Wizards Workshop

Published by Service Admin Support
56-037

February 20, 1981
Issue 11-3

Fig. 3-32. Test equipment setup for check and adjustment of 1st and 2nd LO frequency.

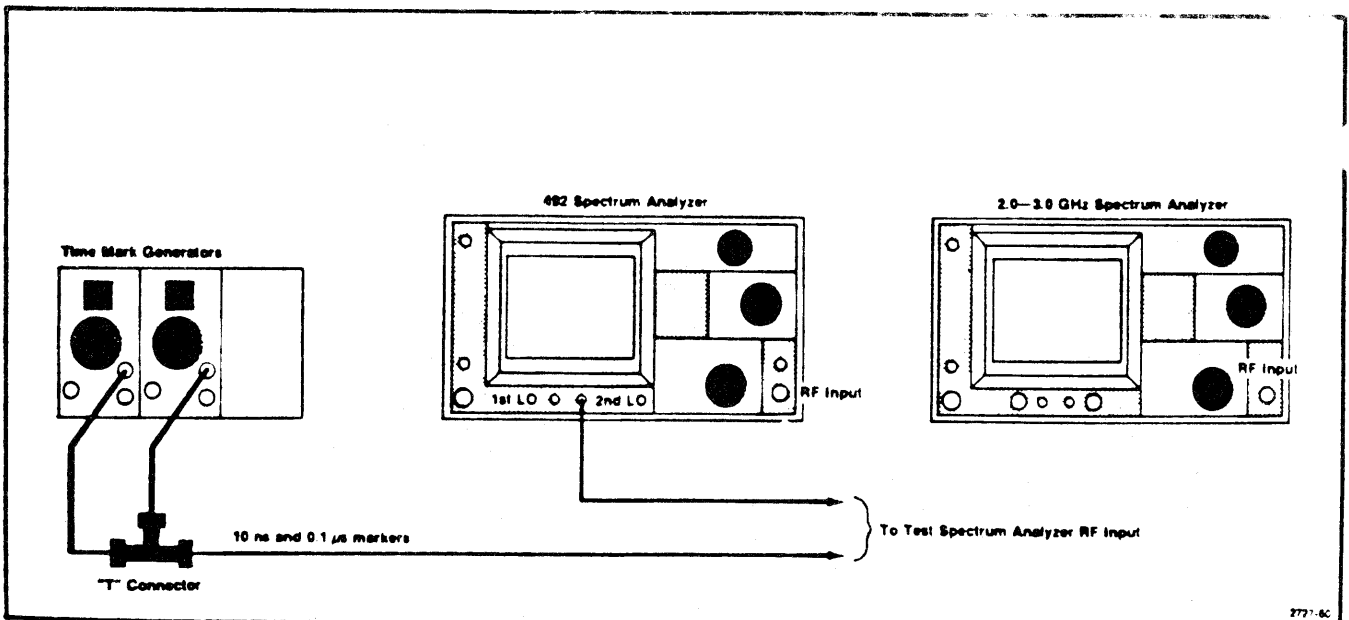
ADJUST 2nd LO FREQUENCY

- A. Test equipment setup is shown in Fig. 3-32. Apply 10ns and 0.1 μ s markers from the time mark generator to the Input of the test spectrum analyzer (frequency range 2.0GHz to 3.0GHz). This should produce accurate frequency markers every 10MHz around a center frequency of 2.2GHz.

- B. Tune the test spectrum analyzer to the 2180MHz marker and reduce the Freq Span/Div to 1 MHz, keeping the 2180MHz marker centered. 2182MHz (correct 2nd LO frequency) signal should appear two divisions above 2180MHz.

- C. Remove the time markers from the test spectrum analyzer Input and connect the 2nd LO output to the test spectrum analyzer input.
- D. Switch the 492 FREQUENCY RANGE to 0-4.2GHz (0-1.8GHz, Option 1) or band 1.

- E. Check--that the 2nd LO frequency is 2182 MHz \pm 1MHz (1 to 3 divisions above the 2180 center frequency with a span/div of 1MHz). If the 2nd LO frequency is out of tolerance, proceed to Step F.

- F. Using a 5/16-inch open-end wrench and a 5/64-inch Allen wrench, loosen the lock nut and adjust the Fine Tune slug in the cavity for a counter reading of 2182.0 MHz \pm 1.0 MHz.
- G. Tighten the lock nut, check the oscillator frequency and, if it is not correct, go back to Step F.
- H. Refer to page 3-43, Step 6 for "2nd L.O. Frequency and Tuning Range Adjustments" in the 492/P Service, Volume 1 (P/N 070-2727-02).

FIGURE 1

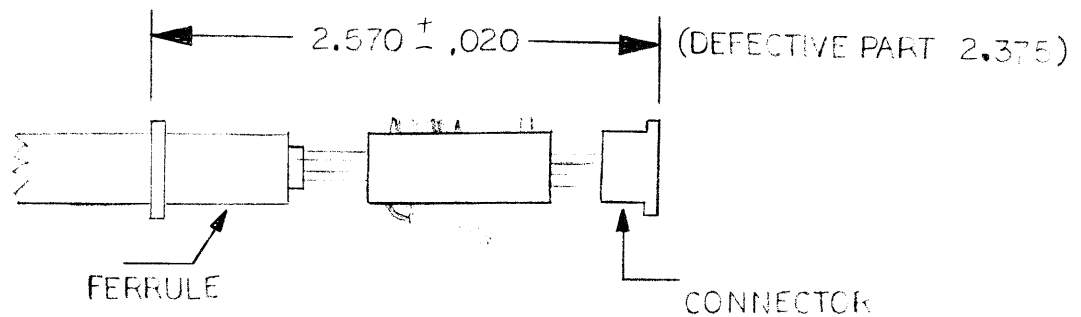
The P6042 probe cable, P/N 175-0431-01, is about 3/16" too short and cannot be plugged into the transformer, (see Figure 1). Since the cable cannot be lengthened, I suggest the present stock be checked and purged as necessary.

FIGURE 1

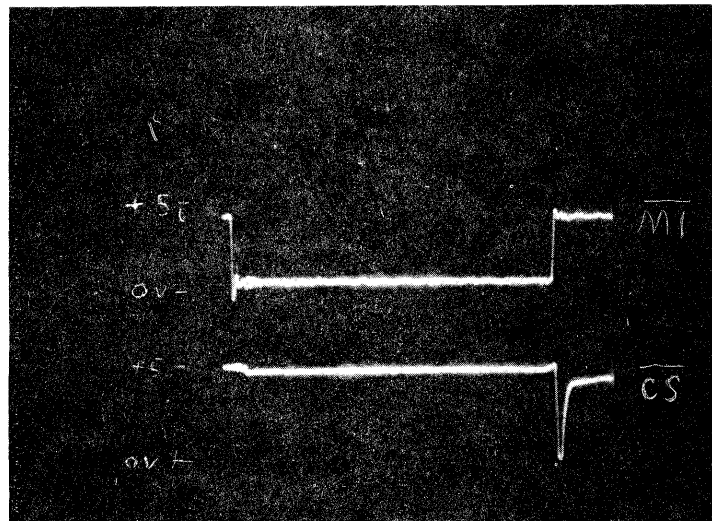
Some 834's before B020540 have experienced timing problems on the processor board (670-6926-00/01) resulting in glitches occurring on the ROM chip selects.

The symptoms can be seen while looping 30 to 50 times on the internal data test resident in ROM. If the instrument experiences chip-select glitches, loss of some character segments on the display will become apparent while running the data test.

The glitch can be seen with a dual trace oscilloscope such as a 475. Attach Channel #1 to U461 Pin 4 (\overline{MI}) and trigger on the falling edge. Select and run the internal data test. Run the test once and check for proper trigger. Next attach Channel #2 to U141 Pins 5, 6, or 7 (these are the chip-select lines for the ROMS). A glitch may occur on either the falling edge or rising edge of \overline{MI} . Pictured in Figure 1 is a gross example of a glitch at the trailing edge of \overline{MI} , indicating a problem. Any glitch exceeding .5 volt in magnitude should be considered a problem.

To fix, install the following:

1. If two 300pf capacitors (P/N 283-0213-00) are connected from Pin 1 to Pin 3 of U321 and from Pin 1 to Pin 5 of U326, remove them.
2. Change U261 from a 74LS260 to a 74S260 (156-0966-00). Note: Bend and lift Pin 9 of the I.C. before installing into the board.

3. Clip off Pins 5 and 6 of U341.
4. With wire, connect Pin 8 of U335 to the vacant pad under Pin 6 of U341.
5. With a wire, connect Pins 9, 10, and 11 of U335 to the vacant pad under Pin 5 of U341.

6. Cut the run from U141 Pin 3 to U321 Pin 3. Connect a 100 ohm resistor (315-0101-00) in series with the run. Add a 220pf capacitor (283-0108-00) from U141 Pin 3 to ground.

7. Cut and lift Pin 2 of U141 and solder to one end of a 100 ohm resistor (315-0101-00). Solder the other end to Pin 13 of U141. Add a 220pf capacitor (283-0108-00) from the elevated Pin 2 U141 to ground (Pin 7).

8. Cut and lift Pin 9 of U261, and solder to one end of a 100 ohm resistor (315-0101-00). Solder the other end to Pin 4 of U261. Add a 220pf capacitor (283-0108-00) from the elevated Pin 9 to ground (Pin 7).

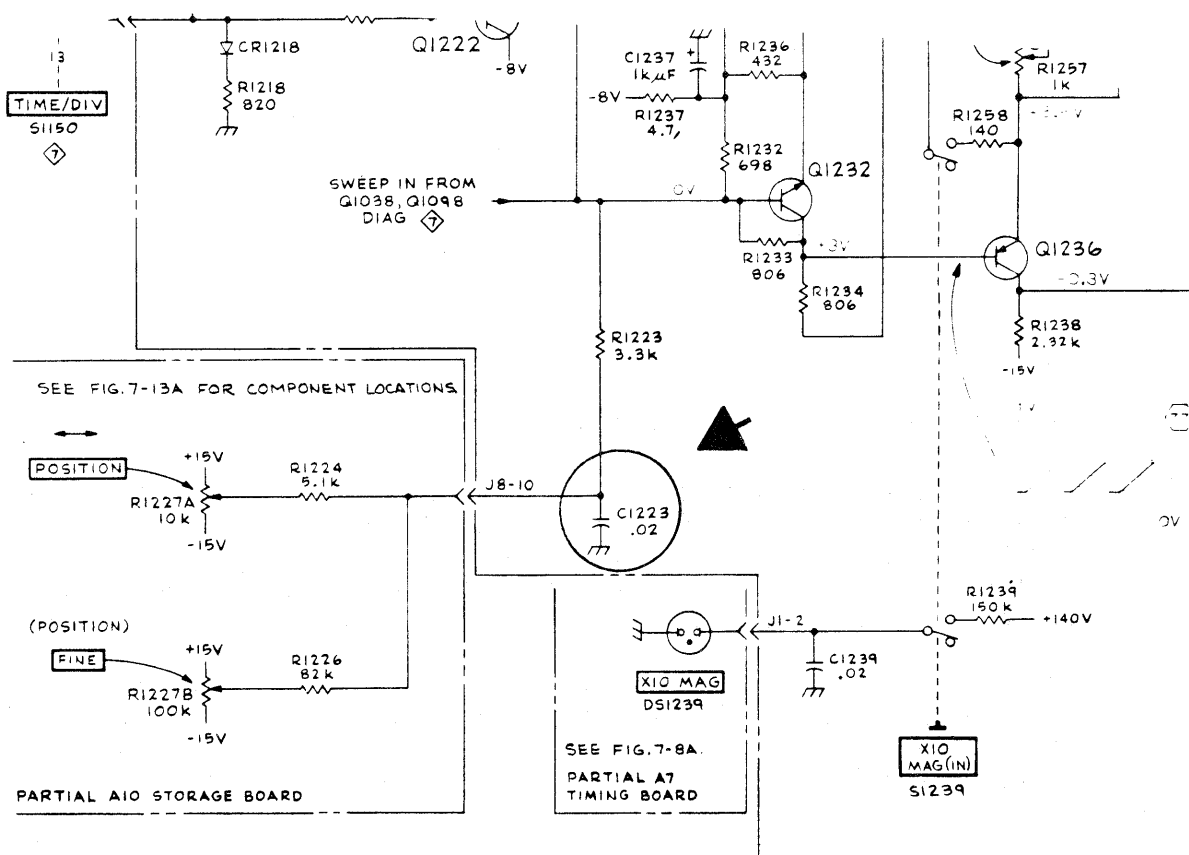
The instruments between these serial numbers have shown a higher than normal failure rate of loose BNC connectors and/or cracked vertical input resistors (R4101, R4201). These instruments were shipped without having LOCKTITE applied to the securing BNC nut. Instruments before and after the serial number break do have LOCKTITE applied and show almost no failures for loose BNC's.

Any instruments in for service which have loose BNC's should be repaired by applying LOCKTITE to the threads of the BNC before the nut is applied. When changing BNC's the same practice is used. LOCKTITE, or any other brand, may be purchased locally or a 10cc bottle ordered as P/N 006-2517-00.

PCB Jumper Locations

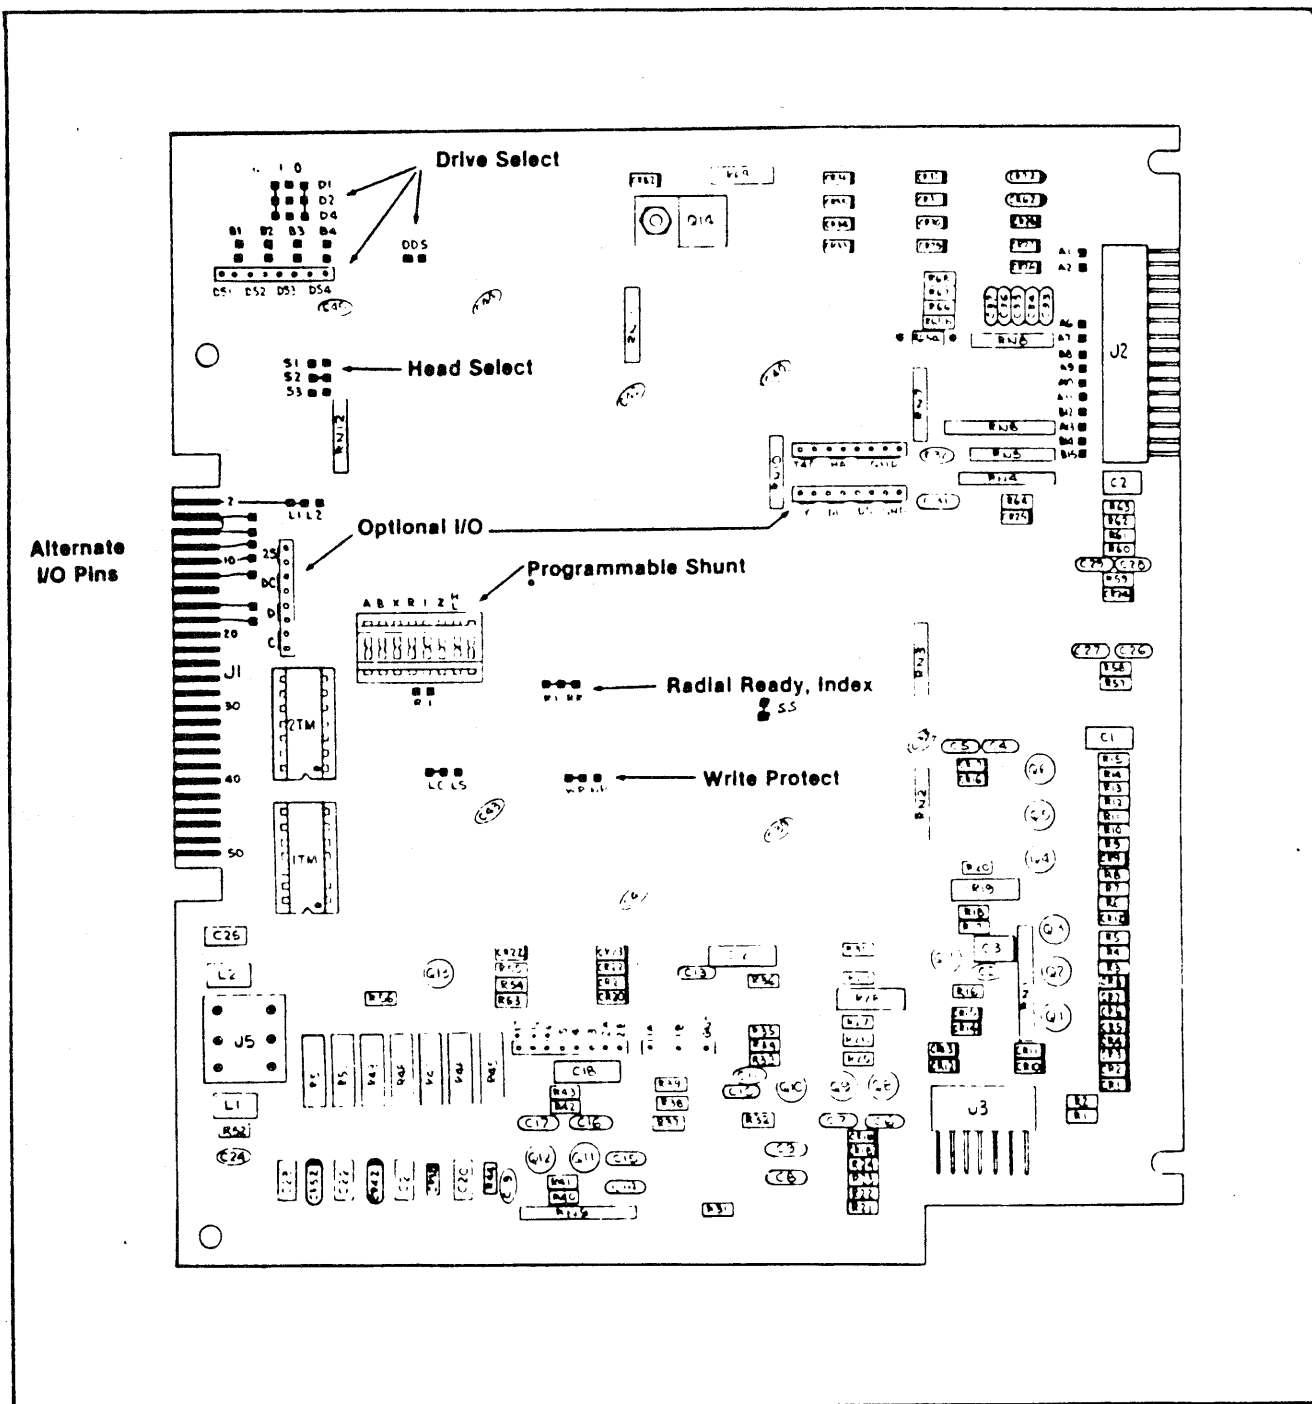
Electrical configuration problem is divided into the following categories:

1. Terminating resistors.
2. Drive select jumper.
3. Optional I/O jumpers.
4. Programmable shunt.

The terminating resistors are installed on the Qume drive control board. The two resistor packs are installed in sockets and labeled 1TM and 2TM (See Figure 1). Only one set (1TM and 2TM) should be used in an 8501 DMU unit. Generally, the set should be installed on the control board in Drive 1. This is to say that Drive 0 should not have any terminating resistors installed and Drive 1 should have terminating resistors installed.

The drive select jumper (P/N 131-0993-00) should be installed on the two pins according to which drive number it is to be used. If the drive is installed in Drive 0 position in the 8501, then the jumper is installed on the 2 pins marked DS1. If the drive is used as Drive 1 then jumper is installed in DS2 position (See Figure 1). There are no added wires or cuttable traces cut.

The optional I/O jumpers (P/N 131-0993-00) are installed on the pins corresponding to pins marked 2S, DC and C. The pins are located near the board edge connector J1. (See Figure 1). Pins marked C are left open.

The programmable shunt is located on control board near the terminating resistors. The shunt is installed in a 16 pin socket. Two (2) of the shorted links labeled B and HL should be cut (opened). Manufacturing, in some drives, cuts the pin off on one side of the shunt to create the open.
